FINAL AGENDA

1. Special Permit (Warehousing)/Montante Construction/5 Research Pkwy. (CONTINUATION) #401-21
2. Special Permit/1070 North Farms Road, LLC/1117 and 2 Northrop Road (CONTINUATION) #402-21
3. Special Permit Revision (vehicle storage & wheel repair/18 Duncan Street, LLC/18 Duncan St. #406-21
4. Zoning Text Amendment (§4.9.B.(10) & §6.11(C)/Small Animal Surgical Services of CT, LLC #501-21
(NO ACTION)

**Re: Traffic Peer Review- Response to Comments
Proposed Delivery Station Building
5 Research Parkway
Wallingford, Connecticut**

SCALE: 1" = 40'
 SHEET: 21 OF 31
 JOB NO.: 1174
 DATE: 05/14/2018
 DRAWN BY: JPC
 CHECKED BY: JPC

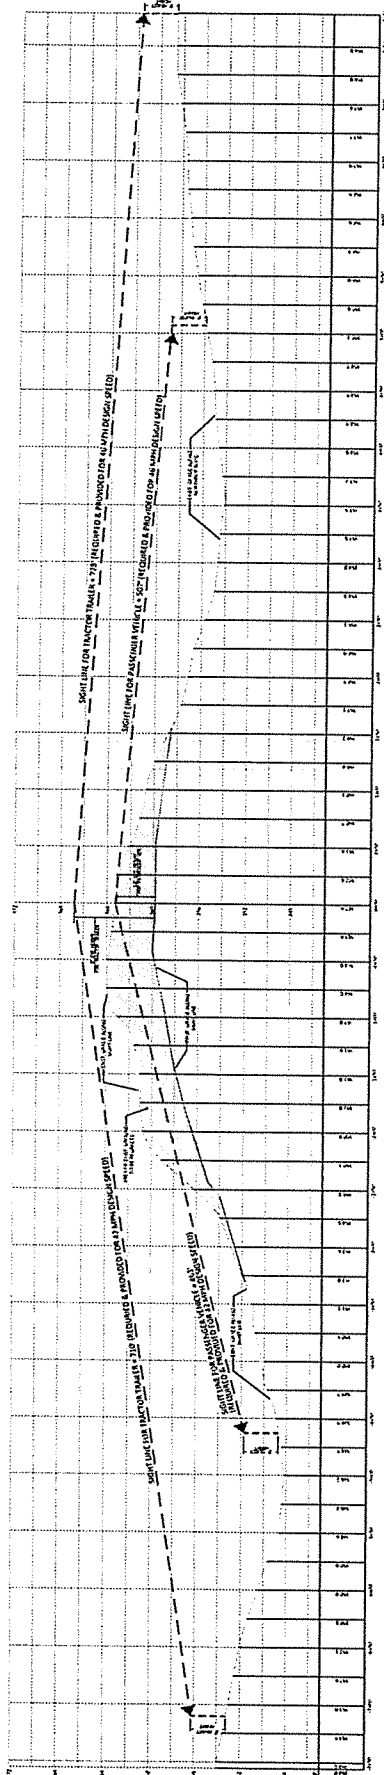
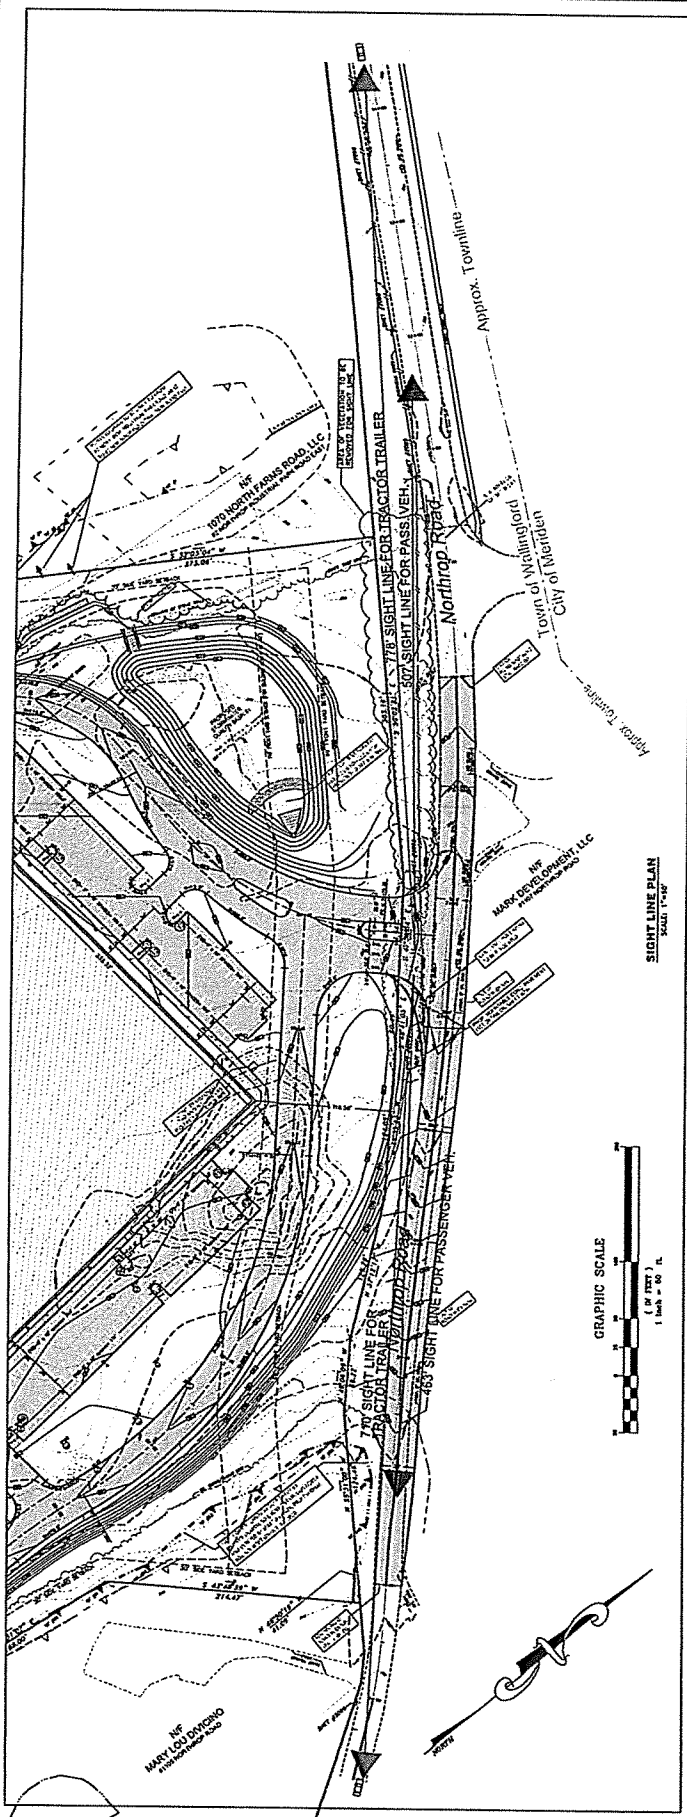
4. In the site plan set provided to us, the sheet index indicates that *Sheet 21, Sight Line Plan & Profile Along Northrop Road (Omitted)*, was removed from the plan set. The consultant should provide a plan and profile of intersection sight distance (ISD) and stopping sight distance (SSD) based on 85th percentile vehicle speeds for passenger cars and tractor trailers. The location where the ATR recorded 85th percentile speeds should be provided as well. Additionally, the plans should show areas of required vegetation clearing within the property and the Town of Wallingford right-of-way (ROW). If/where the 85th percentile speed is not achievable, the maximum sight distance should be shown.

Sheet 21, Sight Line Plan & Profile Along Northrop Road has been incorporated in the plan set and enclosed with this response to comments letter. The area along the shoulder to be regraded is shown on the profile view as demonstrated with a grey hatch. These improvements will address deficiencies in sight distance based upon vertical clearance. The area along the shoulder that requires brush clearing is identified on the plan view as depicted with a callout along the property frontage.

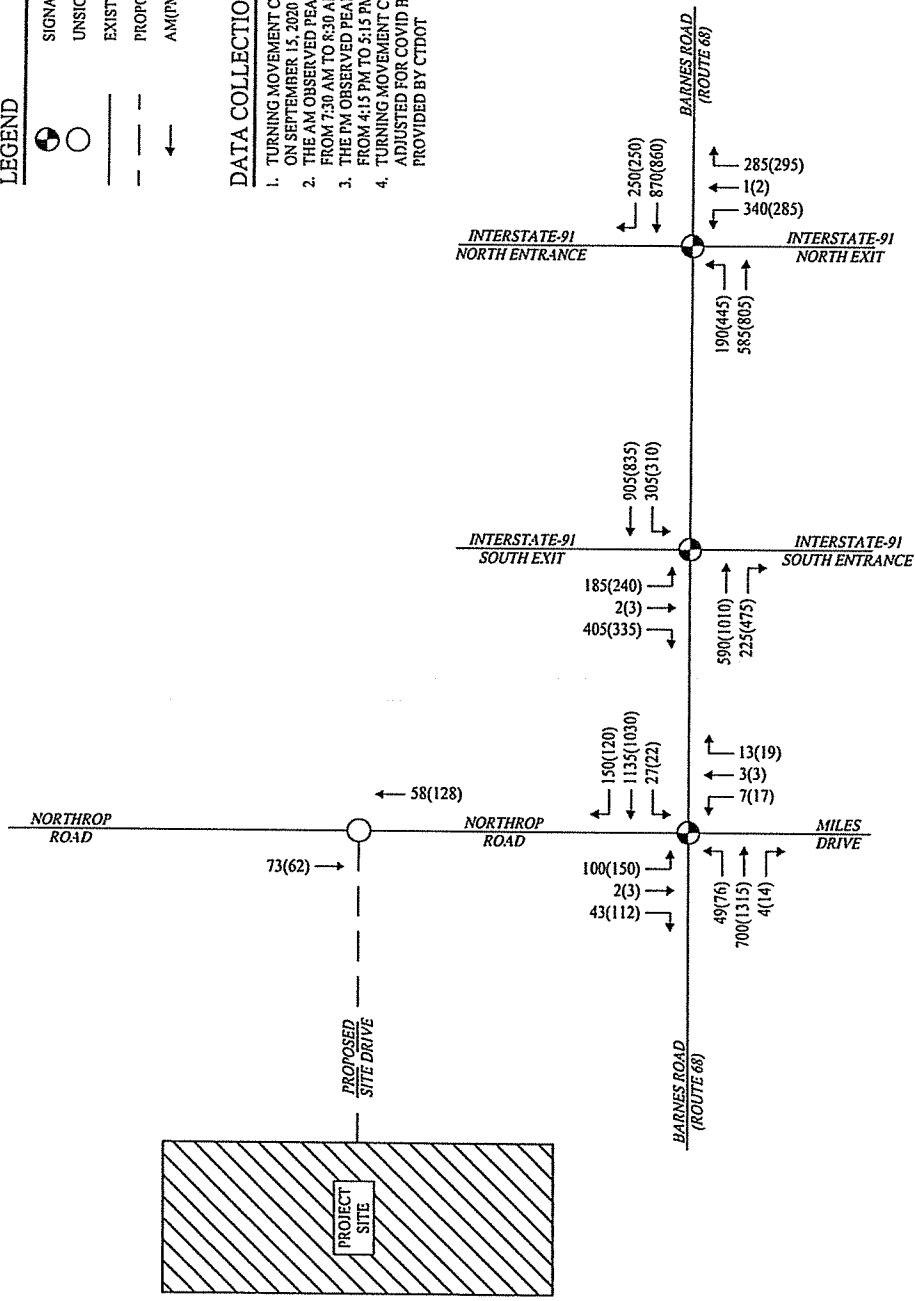
2. The Barnes Road (Route 68) at the Interstate 91 (I-91) ramps traffic volumes in Figure 2 are the same as those used in the traffic study for the 5 Research Parkway project. Those original counts were reported to be collected in October 2018 and adjusted to 2020 by the Connecticut Department of Transportation (CTDOT). The Northrop Road traffic volumes were based on September 2020 manual turning movement counts and adjusted per guidance from CTDOT. Further information about how the traffic volumes used in the assessment were adjusted should be provided.

The existing traffic volumes in Figure 2 were obtained based on manual turning movement count data collected by Solli Engineering on September 15, 2020. The existing traffic volumes were provided to, and reviewed by, the Connecticut Department of Transportation Bureau of Policy and Planning. The volumes illustrated in Figure 2 are those provided by CTDOT.

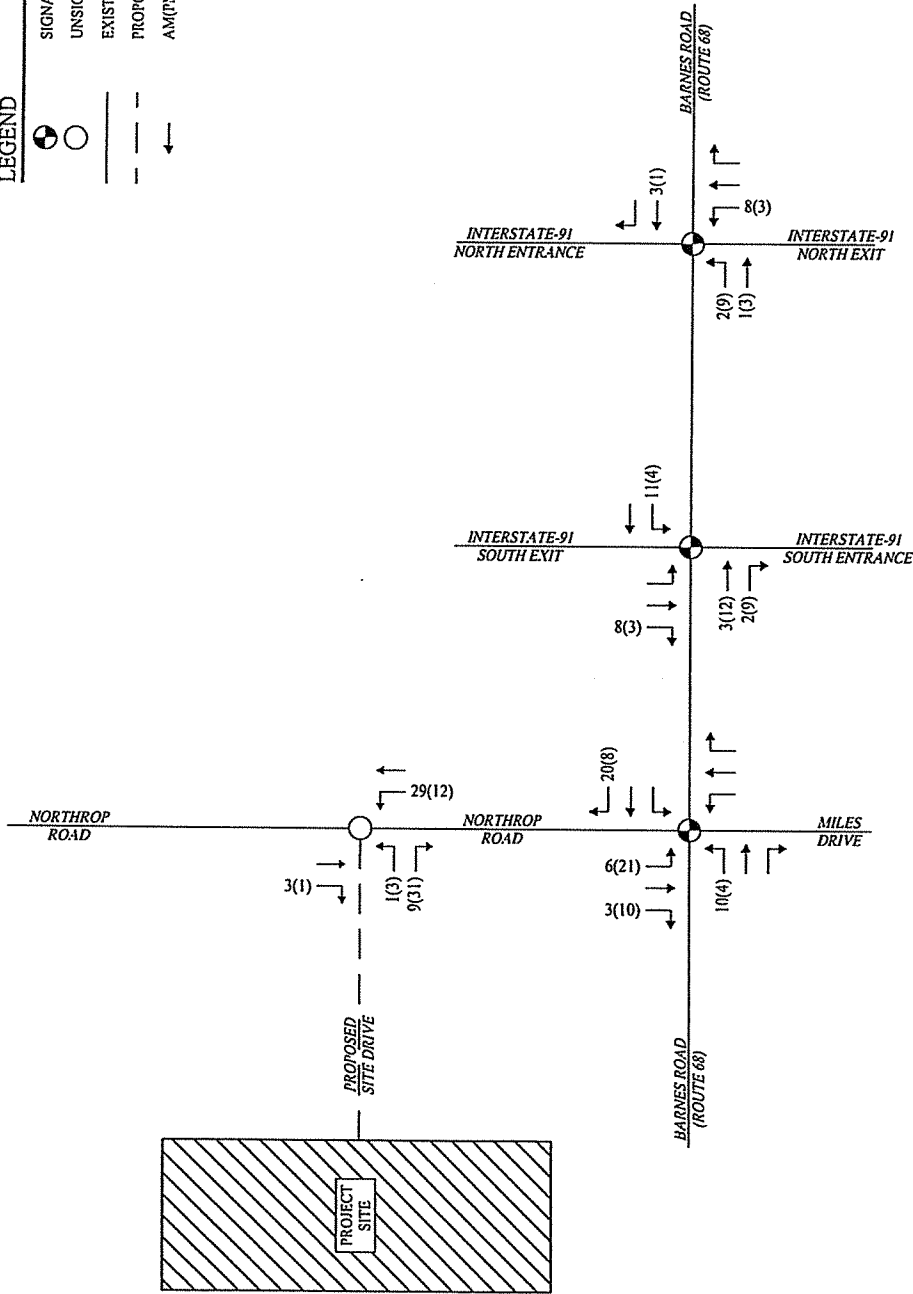
7. In Figure 4, Trip Assignment, the westbound site-generated trips at the Barnes Road-I-91 South intersection are assigned to the left-turn movement. The trips should be assigned to the through movement instead.

Figure 4 has been revised accordingly.
